寄件者: [REDACTED]
寄件日期: 2026年03月11日星期三 12:01
收件者: tpbpd/PLAND
副本: David Chi Chiu CHENG/PLAND; Ivan Sze Yuet FUNG/PLAND
主旨: Re: S. 16 Planning Application No. A/YL-KTN/1157 - Departmental Comments
附件: A-YL-KTN-1157 Drainage Proposal 11-3-2026.pdf
類別: Internet Email

Comments from Drainage Services Department
(Contact Person: Ms. Jessica KWAN; Tel.: 3965 8924)

Please find our comments on the revised drainage proposal for your information.

Project
Temporary Warehouse (Excluding Dangerous Goods Godown) with Ancillary Facilities and Associated Filling of Land for a Period of Three Years at Lots 1354 (Part), 1356 (Part), 1373 (Part), 1374 (Part) and 1375 (Part) in D.D. 109, Kam Tin North, Yuen Long, New Territories
 (Application Number: A/YL-KTN/1157)

Title: Drainage Proposal - LAYOUT D01

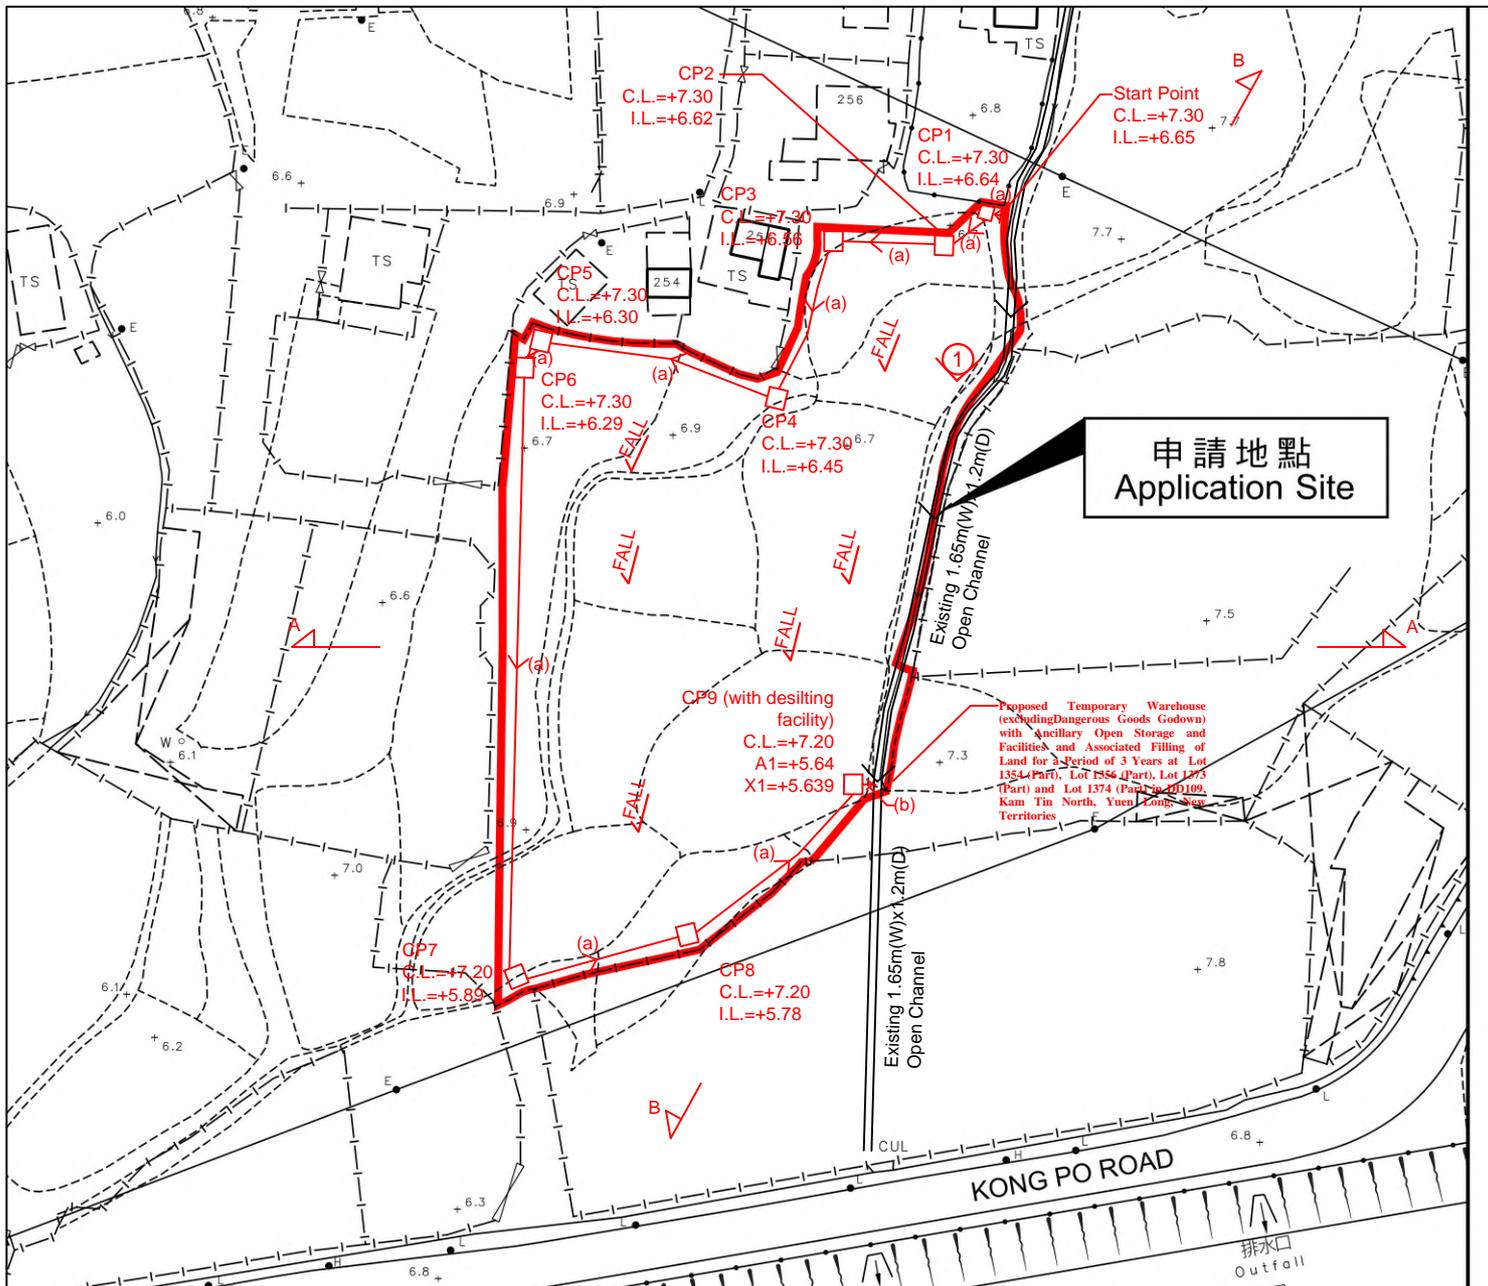
2. The applicant should clarify the proposed site boundary shown in the marked-up sketch which indicates the proposed discharge path.

3. Drawing (No.: D01 & D03): Peripheral surface channels shall be provided along the site boundary to collect the surface runoff accrued on the application site and to intercept the overland flow from the adjacent lands. It is noted that there is proposed land filling works for the development. Proper surface channels should be provided at the lower platform and wall toe to collect the overland flow to/ from adjacent areas. The applicant should clarify extent of land filling works, indicate the proposed and existing ground levels of the application site on the drainage plan and review design of the proposed drainage system such as cover levels and invert levels of the proposed drainage facilities.

Site boundary is revised shown in the marked-up sketch which indicates the proposed discharge path.

An additional section is provided. Please note that the ground profile of the surrounding area is falling away from the site.

Catchment Area Plan for Existing 1.65m(W)x1.2m(D) Open Channel

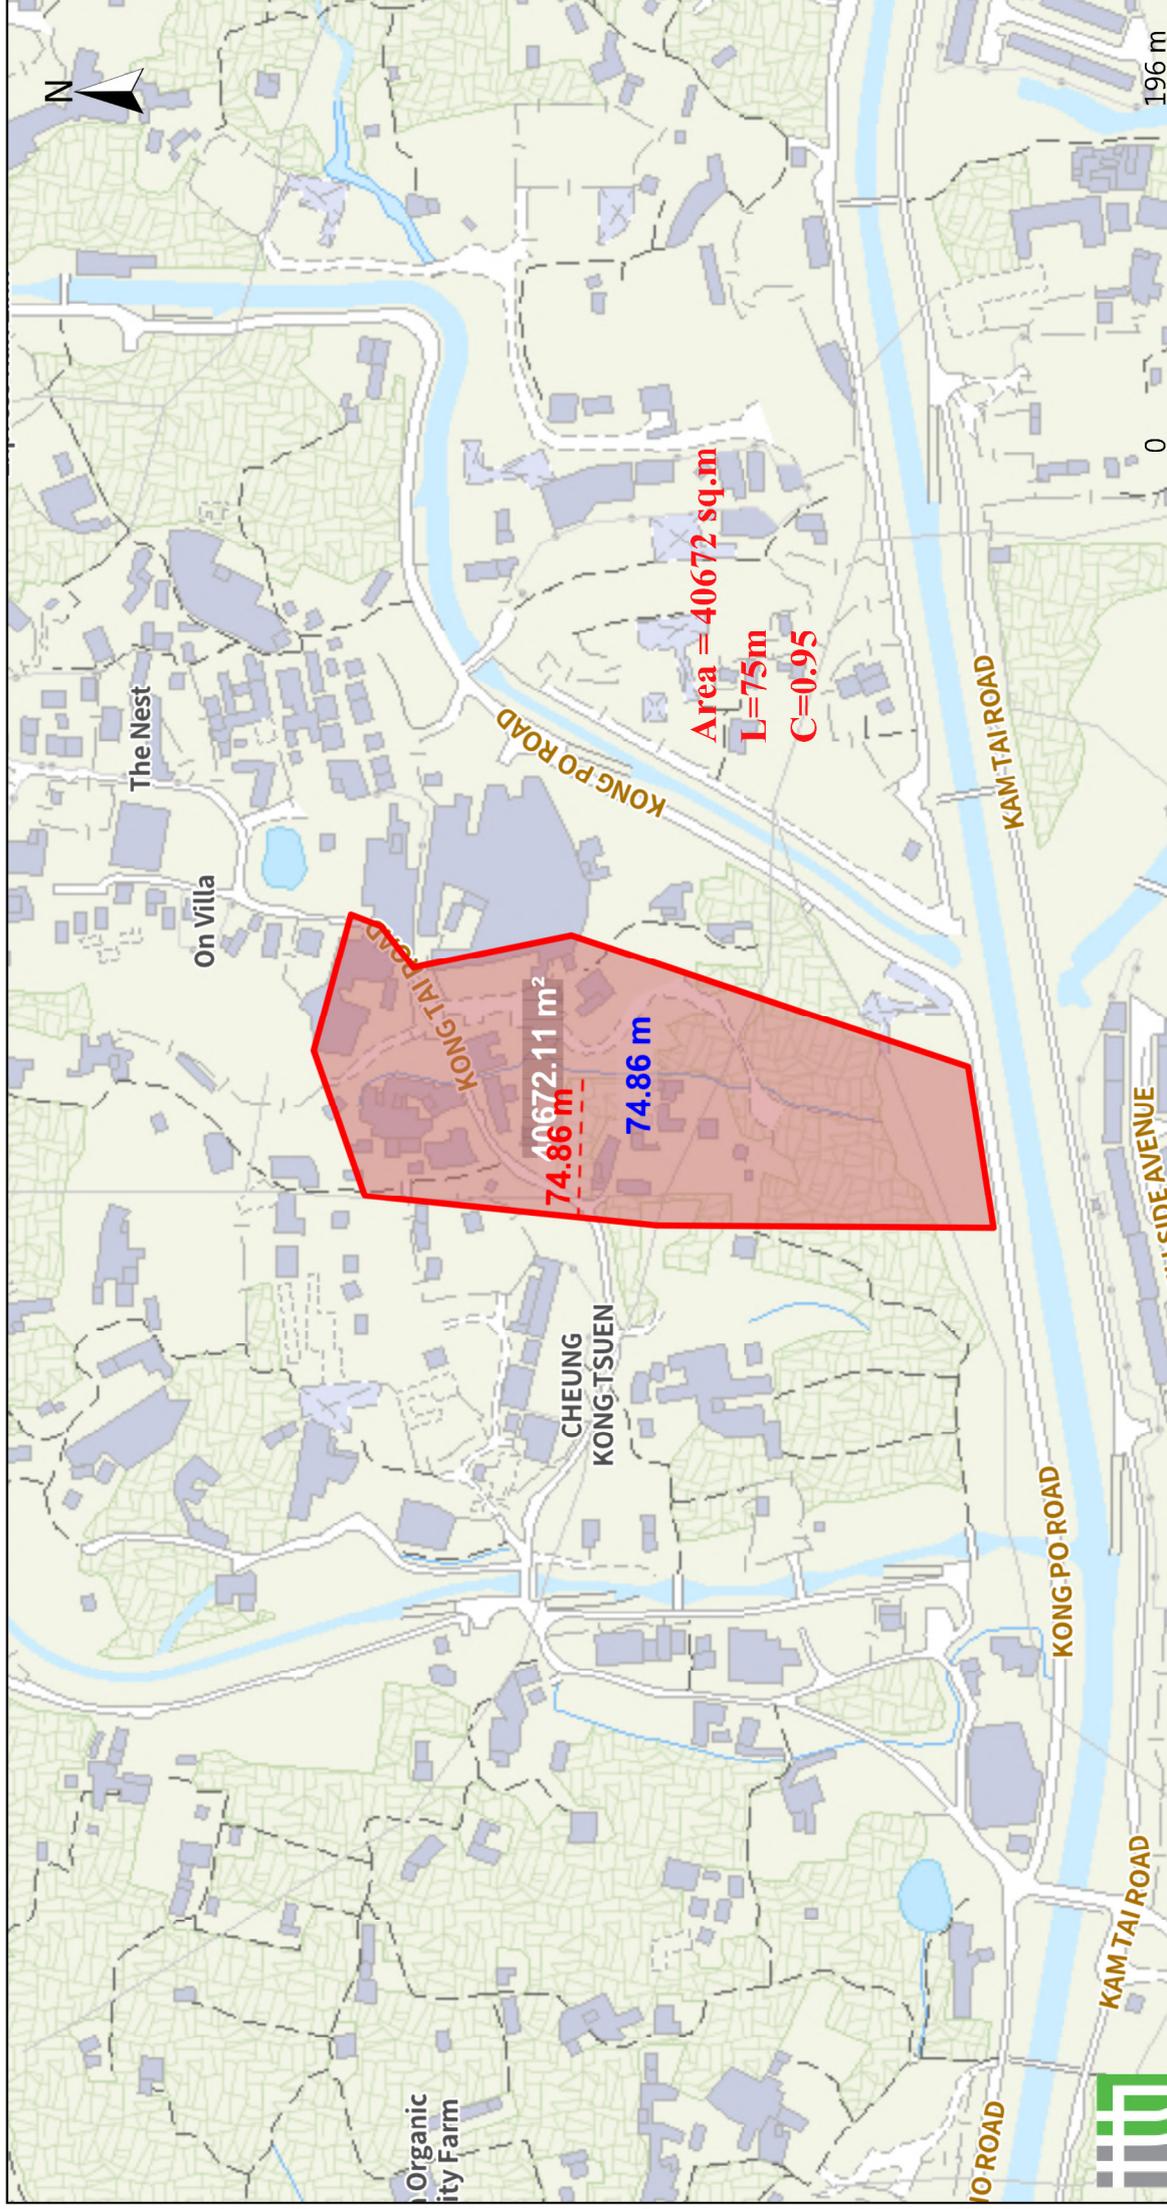
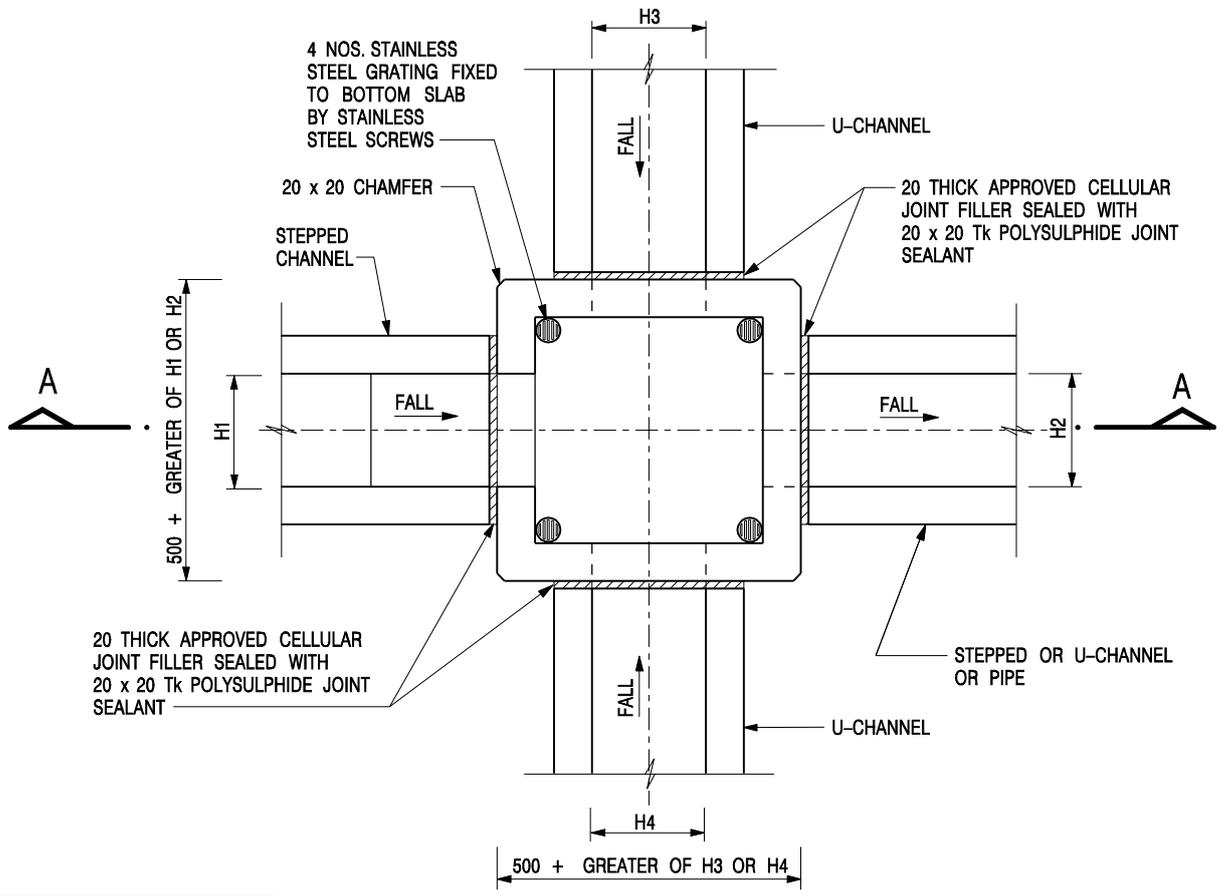
1. For the hydraulic calculation regarding the existing drainage facilities, the applicant should clarify rainfall intensity adopted for checking peak runoff 'Q'. Also, the applicant should review freeboard assumed in the submitted hydraulic calculation.

Calculation is revised. And 300mm freeboard is adopted.
